Amendments to the Drawings

Appl. No.: 10/065,996
Amdt. dated July 8, 2005
Reply to Office Action of April 21, 2005

FIG. 5

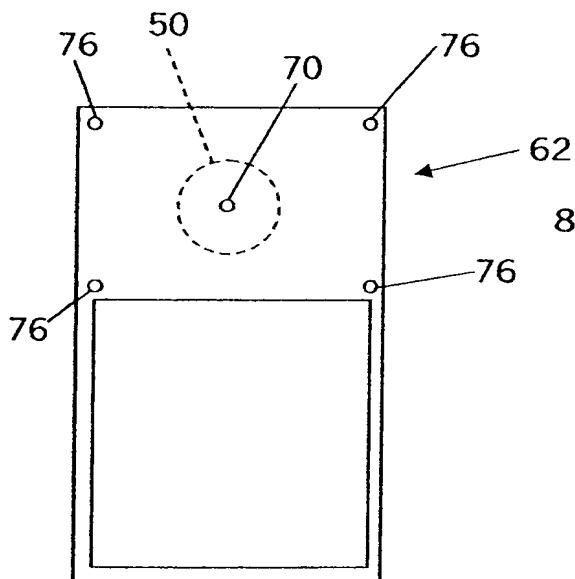
Sheet 2/4 replaces the original sheet 2/4. In FIG. 5, element 82 is redesignated as 76, and element 72 is redesignated as 78, and excess lines that incorrectly designate the inner ends of channels 114 as holes are deleted, all to conform to the specification.

FIG. 6

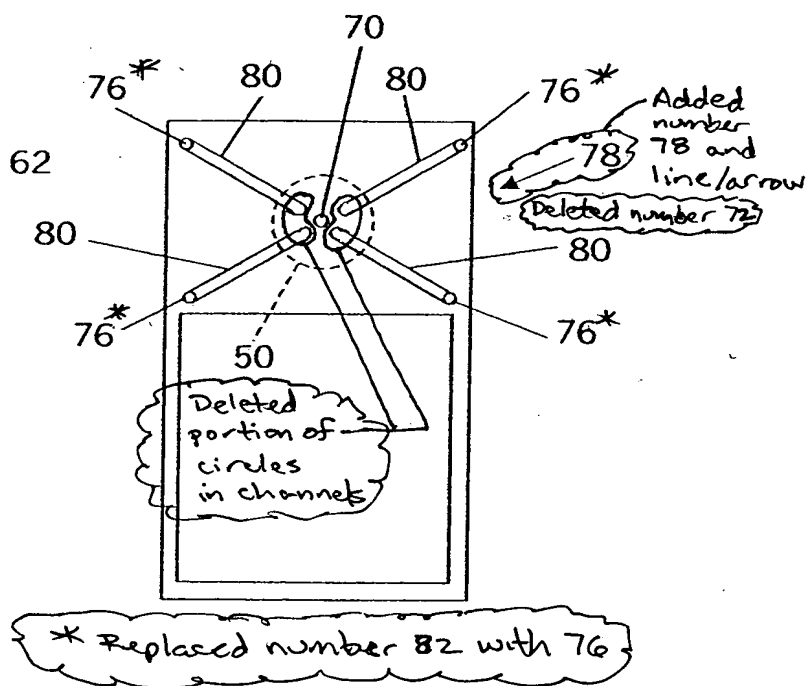
Sheet 3/4 replaces original sheet 3/4. In FIGS. 6, 7, and 8 the previously omitted designation 60 has been added. In FIG. 8 the hatching direction of a portion of part 63 been reversed to clarify that the changed area is a portion of part 63, as shown in corresponding drawings (FIGS. 3 and 6).

FIG. 11

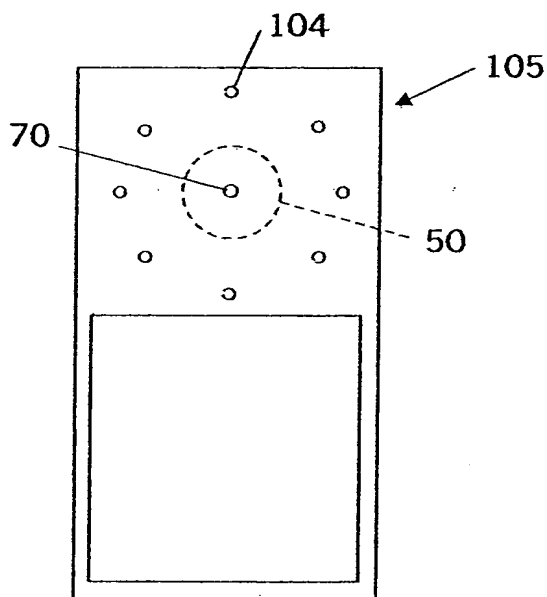
Sheet 4/4 replaces original sheet 4/4. In FIG. 11 the previously omitted element 104 has been added, and excess lines that incorrectly designate the inner ends of channels 114 as holes are deleted to conform to the description in the specification.
